Access Compliance Report Public Rights-of-Way (Curb Ramps)

Main Street: ETON_PL		Cross Street: O_NEILL_DR		Location:	W
ADA ID: RPRK211103154037	Ramp Type: Type 4 - Parallel	Initial Pass/Fail: Fail	Overall Compliance: No	Severity Score:	2
Codes/Mitigation Info/Possible Solution			Field Measurements/Component Compliance

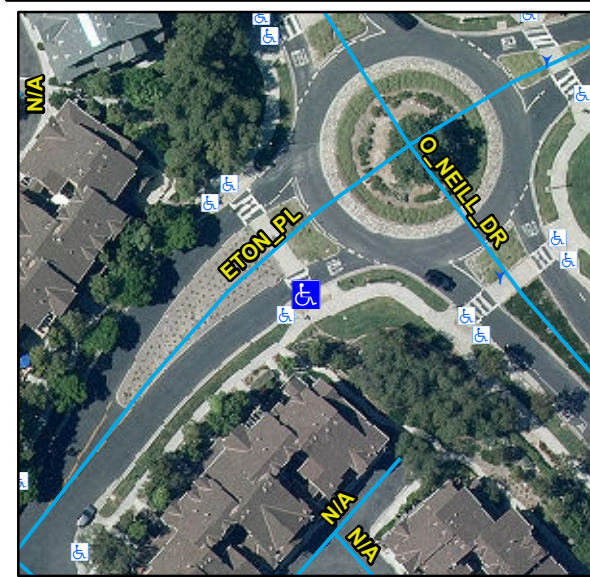
Compliance	Description	Data	Compliance	Description	Data
N/A	Ramp Length LT (in)	116	N/A	Ramp Length RT (in)	-9999
Yes	Ramp Width LT (in)	48	N/A	Ramp Width RT (in)	-9999
Yes	Ramp Run Slope LT (%)	5.3	N/A	Ramp Run Slope RT (%)	-9999
No	Ramp Cross Slope LT (%)	2.4	N/A	Ramp Cross Slope RT (%)	-9999
N/A	Landing Present	N/A	N/A	DWS Provided	N/A
N/A	Landing Length (in)	N/A	N/A	DWS Contrast	N/A
N/A	Landing Width (in)	N/A	N/A	DWS Length (in)	N/A
N/A	Landing Run Slope (%)	N/A	N/A	DWS Full Width	N/A
N/A	Landing Cross Slope (%)	N/A		DWS Offset Type	N/A
N/A	Landing Movement Obstructed?	N/A	N/A	DWS Offset Left (in)	N/A
	Landing Movement Type	N/A	N/A	DWS Offset Right (in)	N/A
N/A	Landing Shared	N/A			
N/A	Clear Space	N/A			
N/A	Clear Space To Crosswalk (in)	N/A			
N/A	Marked Crosswalk 1	Yes	N/A	Marked Crosswalk 2	N/A
	Crossing 1 Direction	N		Crossing 2 Direction	N/A
	Marked Crosswalk 1 Width (in)	144		Marked Crosswalk 2 Width (in)	N/A

N/A	Ramp Inside Crosswalk 1	Yes	N/A	Ramp Inside Crosswalk 2	N/A
	Crossing 1 Slope (%)	3		Crossing 2 Slope (%)	N/A
	Crossing 1 Cross Slope (%)	1.6		Crossing 2 Cross Slope (%)	N/A
N/A	Gutter Ponding	N/A	N/A	Curb Slope	15.3
Yes	Gutter Lip Height (in)	0		Road Run Slope (%)	N/A
N/A	Gutter Run Slope (%)	N/A		Road Cross Slope (%)	N/A
N/A	Gutter Cross Slope (%)	N/A	Yes	Perpendicular Joint Present	Yes
Yes	Overall Surface Condition	Acceptable			
	Cross Gutter Present?	No		Spandrel Present?	No
	Replace Cross Gutter?	N/A		Replace Spandrel?	N/A

Remove & Replace Entire Ramp.
